15. Seat

047BO008Y

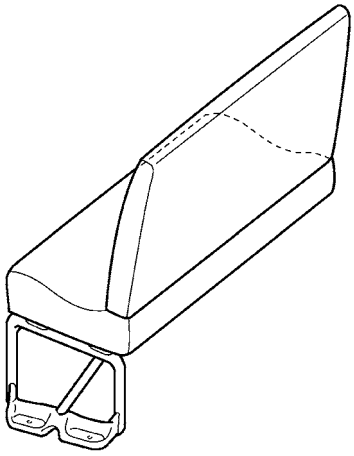
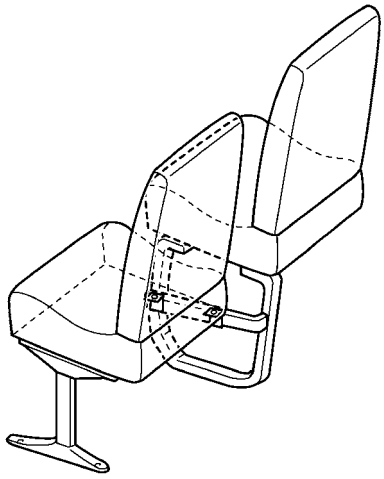
- The sixth-row 2-seater separate seat has been changed to the 2-seater bench seat on the Australia models.

▶ Standard Wheel Base Models ◀

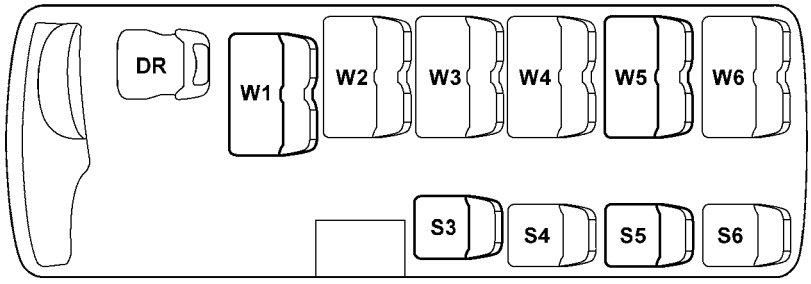
- The positions of the passenger seats have been changed on the standard grade of the Hong Kong models. The shifted distance of each seat is as follows:

Seat	Lateral Shifted Distance (to Center)	Vertical Shifted Distance (Upward)
W1	96 mm (3.8 in.)	32 mm (1.3 in.)
S3	49 mm (1.9 in.)	—
W5, S5	—	70 mm (2.8 in.)

▶ Long Wheel Base Models ◀

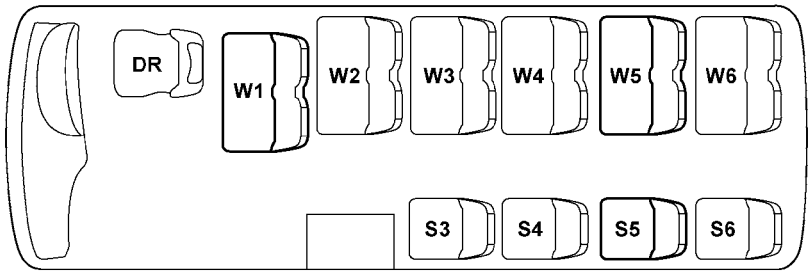
Seat	Lateral Shifted Distance (to Center)	Vertical Shifted Distance (Upward)
W1	96 mm (3.8 in.)	32 mm (1.3 in.)
W5, S5	—	70 mm (2.8 in.)

: Semi High Back Passenger Seats

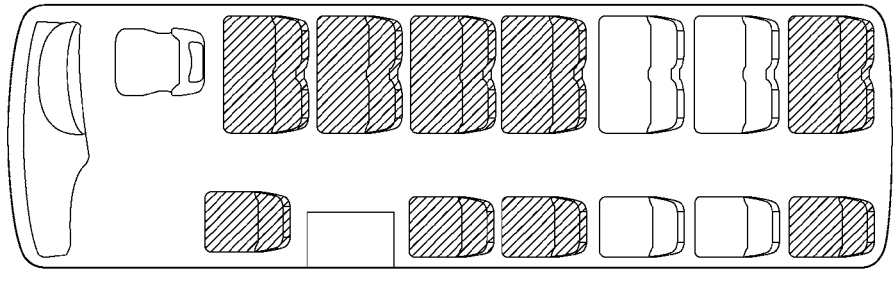
- Several passenger seats have been changed to the semi high back seats on the standard grade of the Australia models.
